Yorkshire
Wildlife Trust

Yorkshire Wildlife Trust Consultation Response: Calderdale Energy Park (CEP) NSIP, Preliminary Environmental Investigation Report (PEIR)

Figure. 1:
Calderdale Energy Park - Onshore wind opportunity showing sensitivity and constraints WFS | RSPB Open Data Map (YWT QGIS)

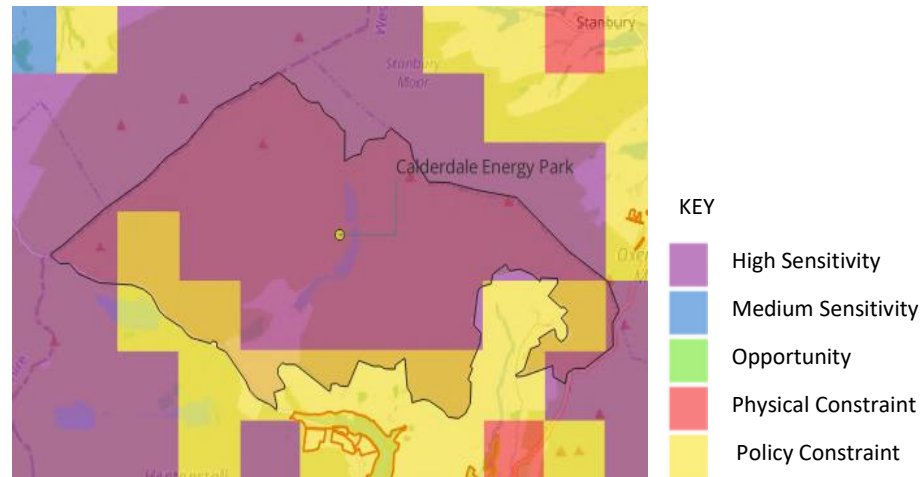
Resultantly, it does not seem probable that no other alternative sites could be identified. As shown below in *Figure.1*, the Site is either highly ecologically sensitive or restricted from development by policy constraints²⁴, which suggest it to be entirely unsuitable for onshore wind deployment.
